P.A. Knit Composite Ltd.

20th April 2014

Observations

Steel superstructure at 3rd Floor - Roof

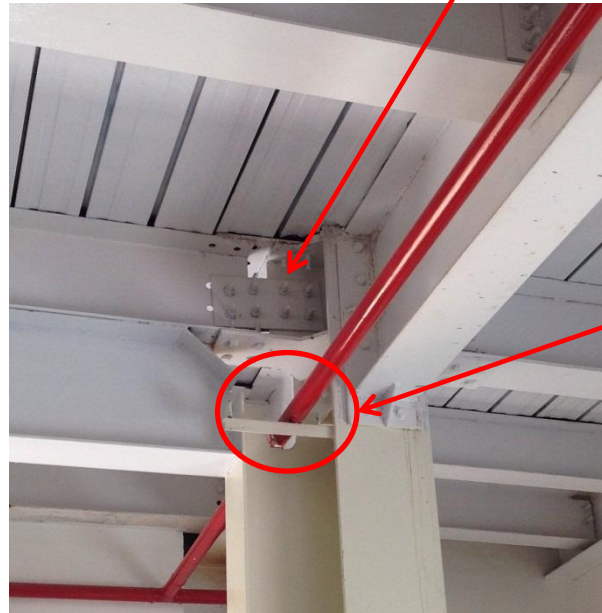
Lateral stability to steel frame appears to be reliant on portal braces at locations shown. These are provided in one direction only. Connections of braces to main structure and ability to act as lateral frame to be reviewed

Weld quality appears poor and should be reviewed

Columns out of plumb at 5th floor

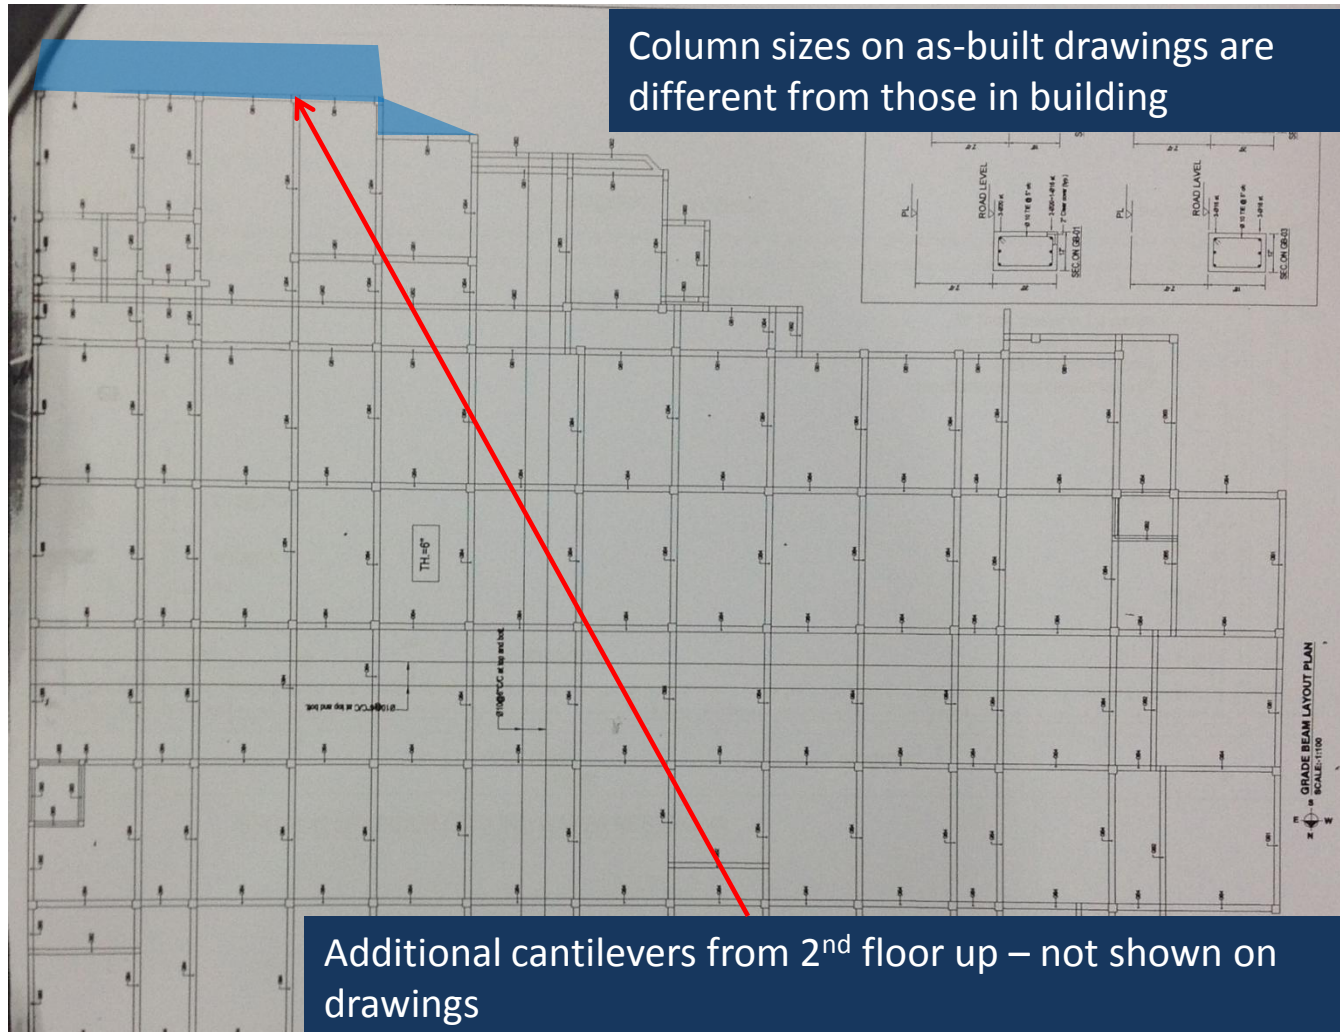
Fire protection details of steel members not known

General lack of fit of connections in steel frame

Site modifications to bracing members

Flat Slab Structure at 3rd Floor

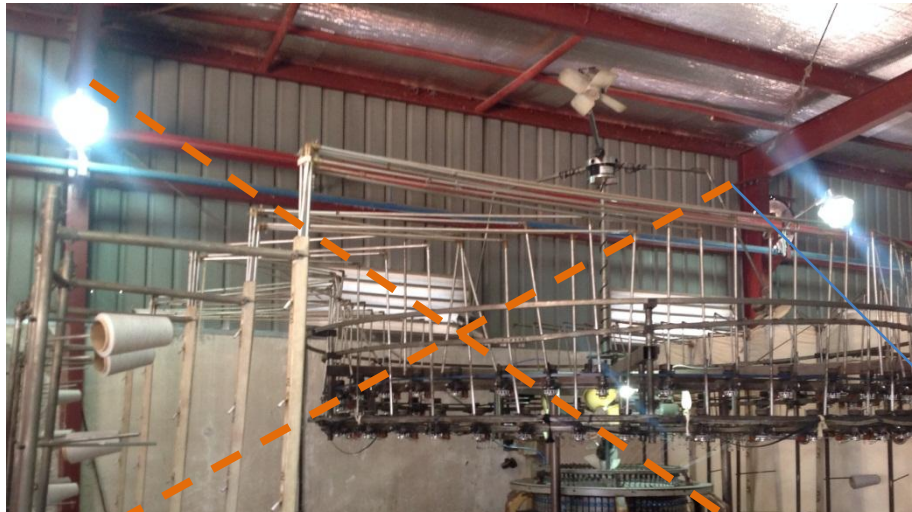
As-built drawings do not match as-built structure

As-built drawings not accurate
